United States Department of the Interior

July 8, 2016

9043.1 ER 16/0249

Subject: Draft Environmental Impact Statement (DEIS) for the Proposed Atlantic Sunrise Project (Pennsylvania, Maryland, Virginia, North Carolina, South Carolina) (FERC Docket No. CP15-138-000)

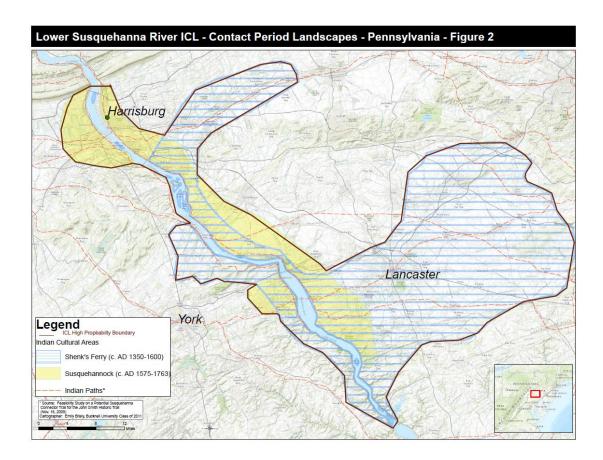
The Department supports a route that avoids in large part lands recently protected through the FERC license issued in the Holtwood Project¹ and associated settlement agreement. The Department through its bureaus the U.S. Fish and Wildlife Service (USFWS) and the NPS were active participants in that proceeding, and supported the protection of those lands².

Although they do not contain any specific USFWS or NPS units, these lands do possess important characteristics associated with preserving the landscape evocative of the time of Captain John Smith's voyages of discovery and their protection was an integral part of accomplishing the Administration's America's Great Outdoors (AGO) initiative and the Commonwealth of Pennsylvania's Conservation Landscape Initiative. Recent discoveries also indicate the potential for additional discovery of cultural resources associated with the Captain John Smith Trail in the area of the proposed pipeline. The Department again presents a map of contact period landscapes in the Lower Susquehanna River area that may prove useful in FERC's assessment of the potential impacts of the pipeline project. Since the DEIS only lists archeological sites in the immediate APE, it is not clear whether or not FERC or Transco considered the impact of PHMC registered sites located near the pipeline's current route.
